Subject: Proposed Silo Ridge access road

Per your request, we have reviewed the draft proposal of Silo Ridge Ventures, the adjacent landowner, to utilize a portion of your landfill property for their residential development. As you know, our firm has been directly involved with matters relating to the Harlem Valley Landfill since 1988. We performed the pre-closure site investigation, negotiated the terms of the closure plan with the DEC; oversaw closure activities for the owner, co-authored the closure certification report, and have conducted post-closure monitoring at the site since its closure in 1996.

Silo Ridge Resort Community
Sketch DE-54

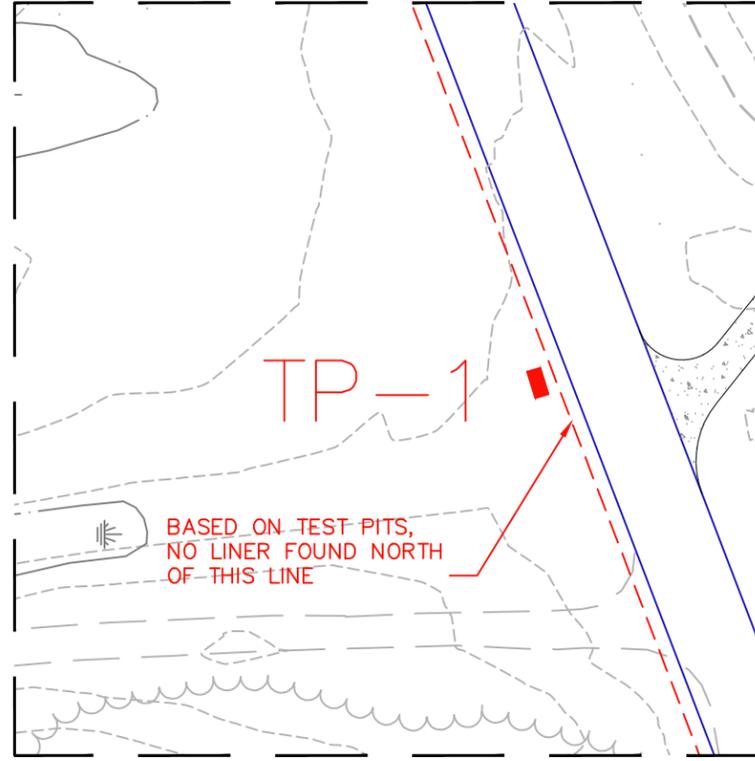
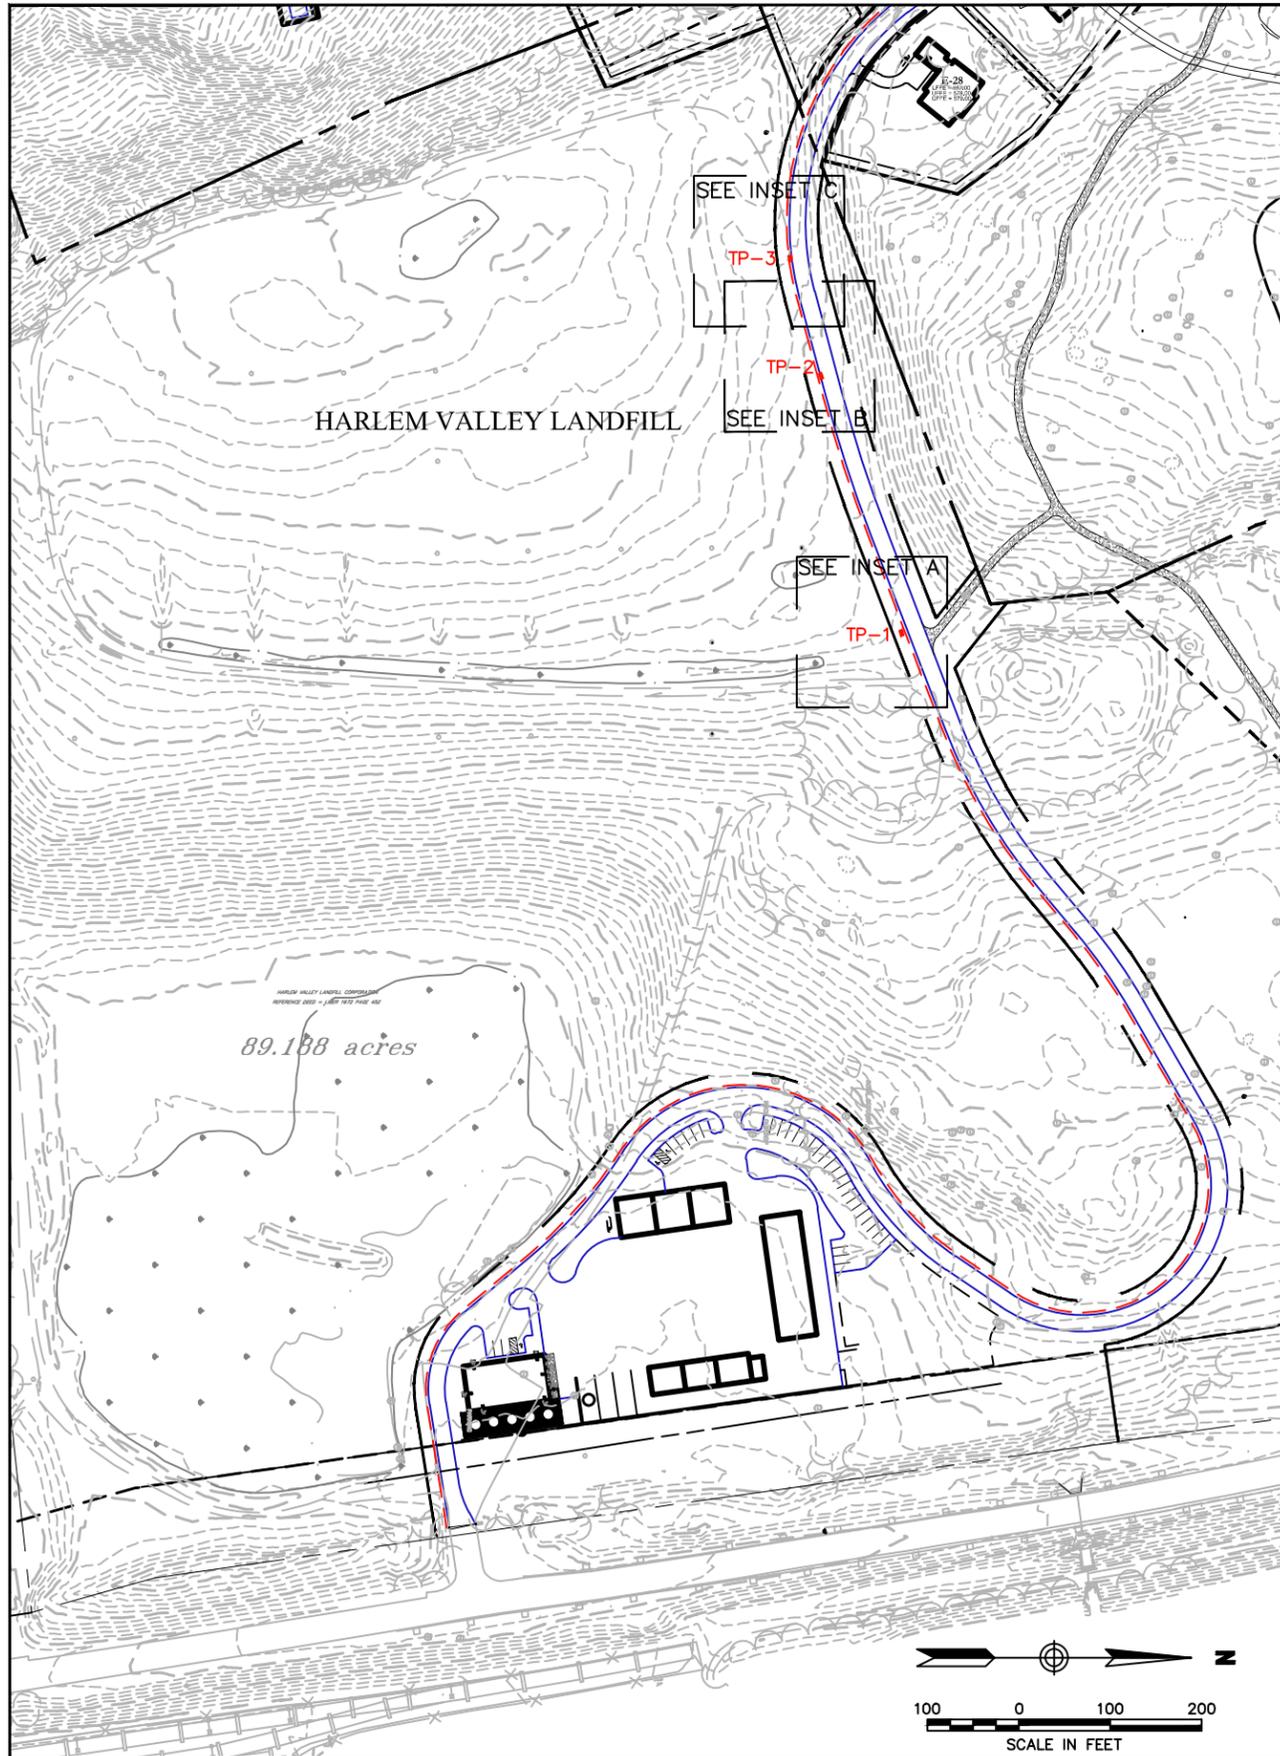
We understand that Silo Ridge proposes to construct an access road across your property in the vicinity of the landfill to serve their residential development. Review of test pit data and a draft design plan for the road indicates that the new access road will not cross the landfill footprint or the geosynthetic cap that was placed over the waste mass during the closure of the landfill. Construction of the roadway will not require the relocation of any monitoring wells or other monitoring points and will not prevent continuing environmental monitoring of the site.

Final plans for development of the access road should be reviewed by our firm and the limits of the area of disturbance delineated in the field for our inspection prior to commencement of any construction so that we can verify both our findings and conformance with NYSDEC requirements. Do not hesitate to contact this office if you would like additional information on this issue.
